SUMMARY EXPERT OPINION INDEPENDENT VERIFICATION: OVERSHADOWING ANALYSIS

**s.96 Application
94-98 George St Hornsby**

1 June 2017

Property: 94-98 George St Hornsby
Approval: DA | s.96 application

Figure 2: Verifying the azimuth angle

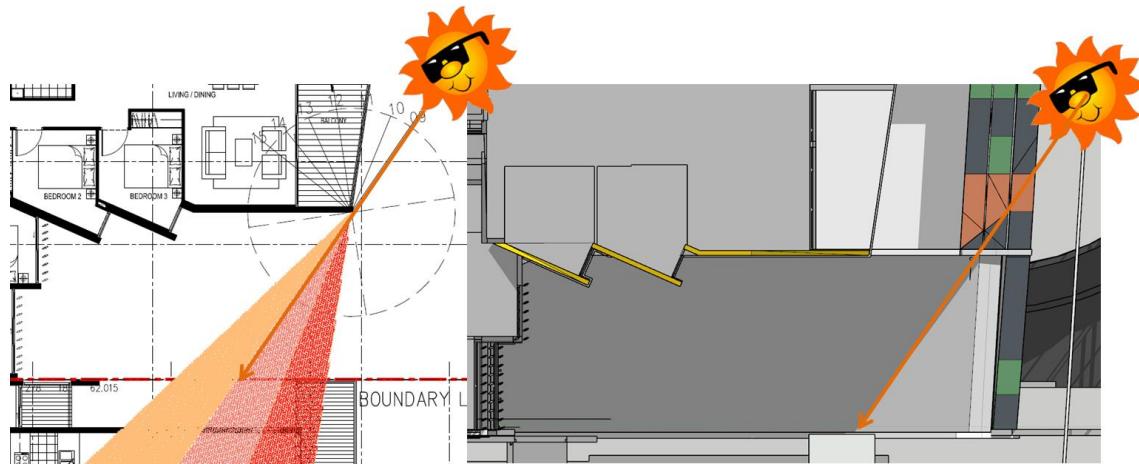
I first confirm whether the designated azimuth angles are correct, by comparing the applicant's diagram with a top-down view of the shadow as it appears in my calibrated 3D digital model, set for 9 am on June 21. See Figure 2.

I note an approximately 1° discrepancy between the two angles. Explanation: At Hornsby, the MGA North (grid north) supplied on conventional surveys, is almost exactly 1° different to True North. This small discrepancy is effectively irrelevant in quantifying solar access and overshadowing, and may be safely disregarded.

Figure 3: Detail. Interpreting the azimuth angle 'fans'

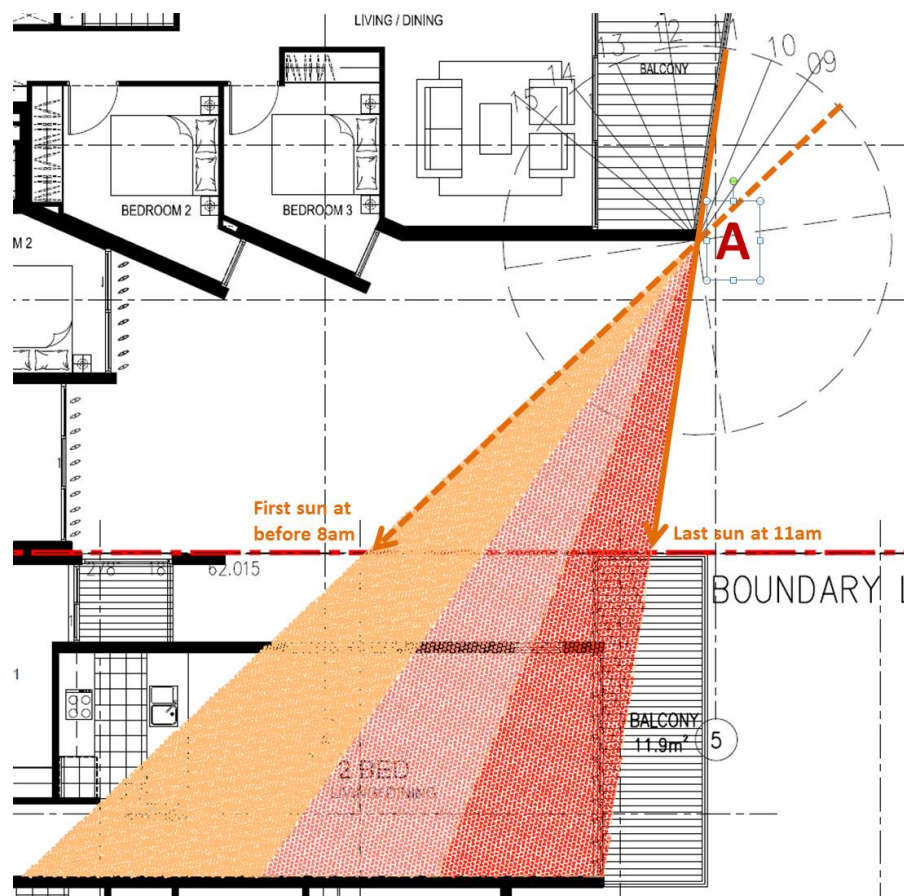
In Figure 3, point **A** in plan remains unchanged between the approved DA and the s.96 application. The significance of this point is that it determines the extent of overshadowing for the north-east corner apartment in the 14 story 'Avanti' building at 90 George Street.

I note that interpretation of 2D azimuth angle 'fans', as with conventional plan and elevation shadow diagrams, may be inadequate to conclusively quantify overshadowing impact or solar access. Therefore I present the same condition in the form of 3D projections which clarify the information.

Table 1: Views from the sun 9am to 11am

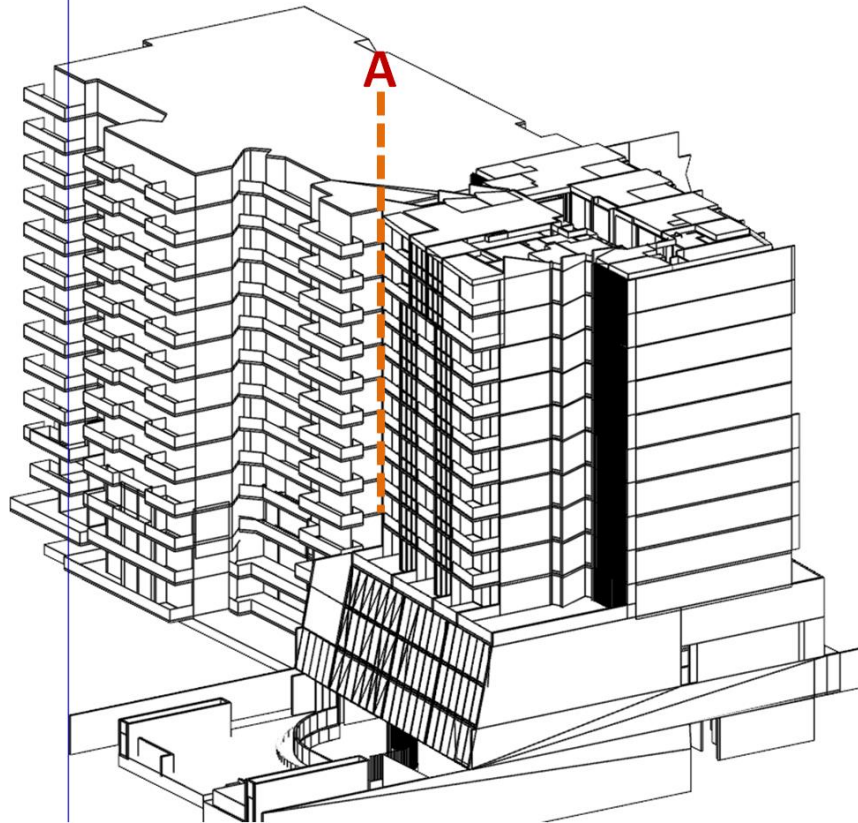
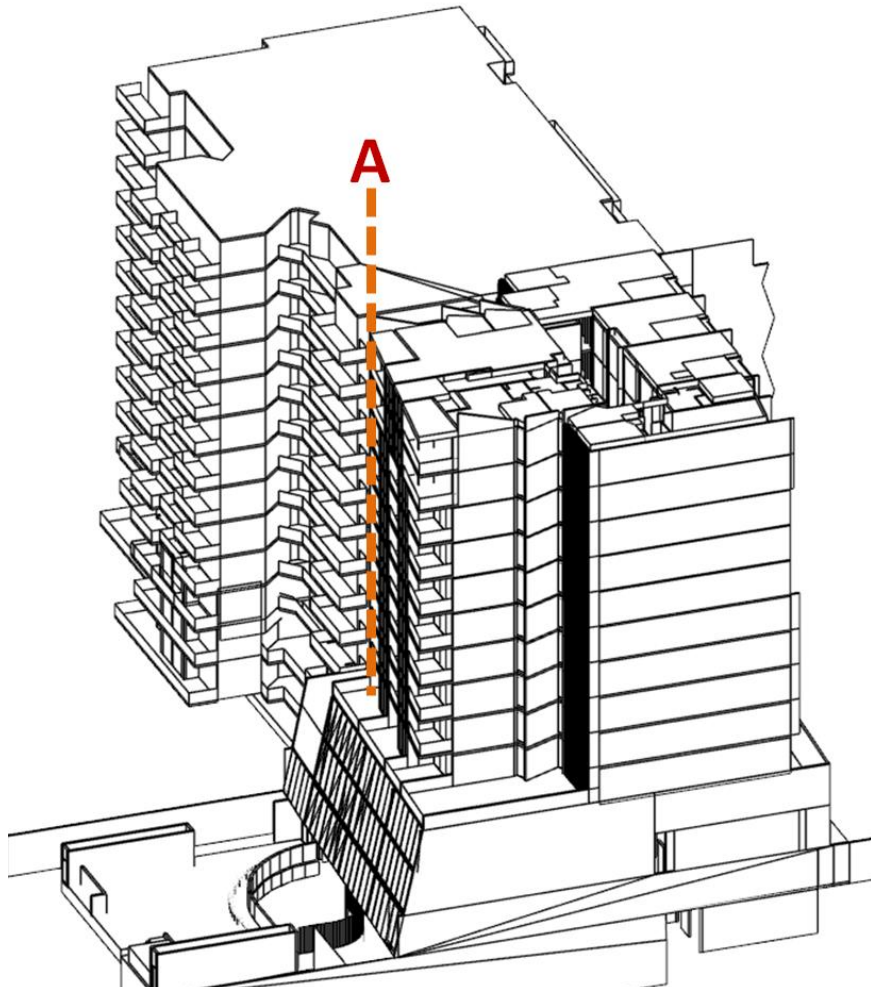
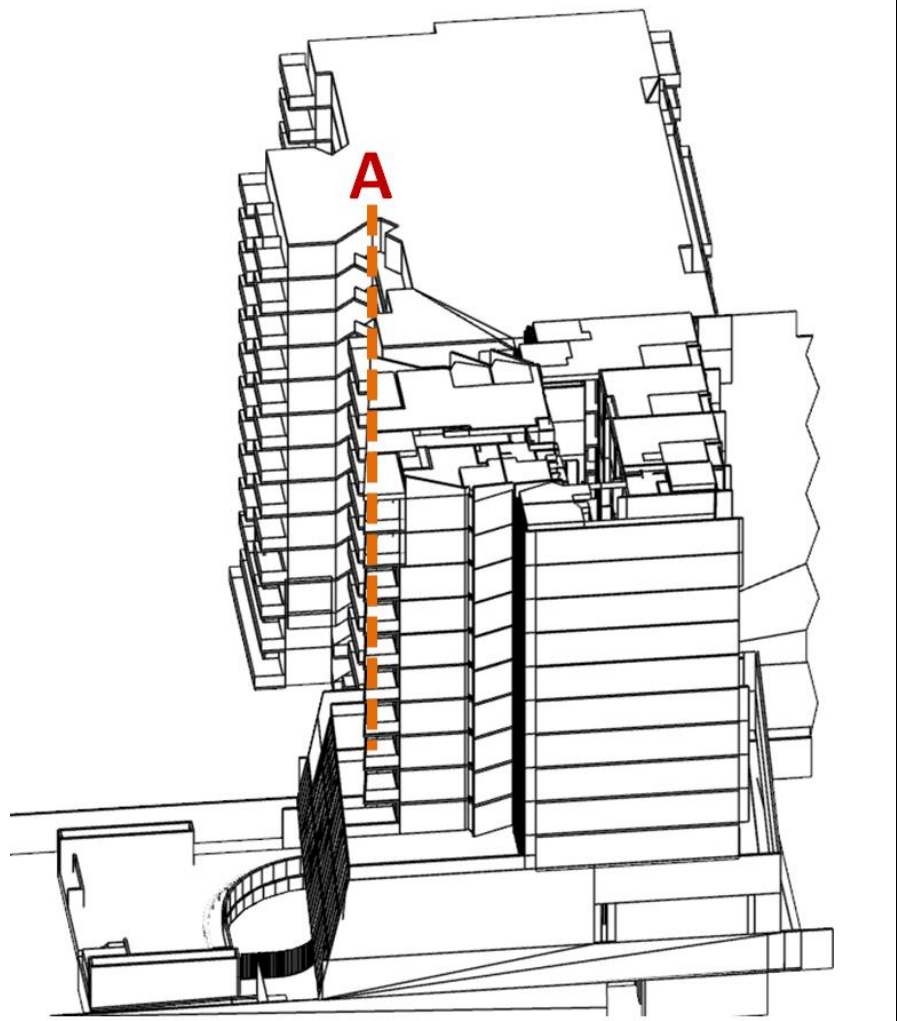
I note that the 3D view at 11am shows slightly less of the affected verandas and living room glazing than suggested by the Applicant's 2D 'fan'. In the context of the full sun access before 9am, I consider this small discrepancy negligible.
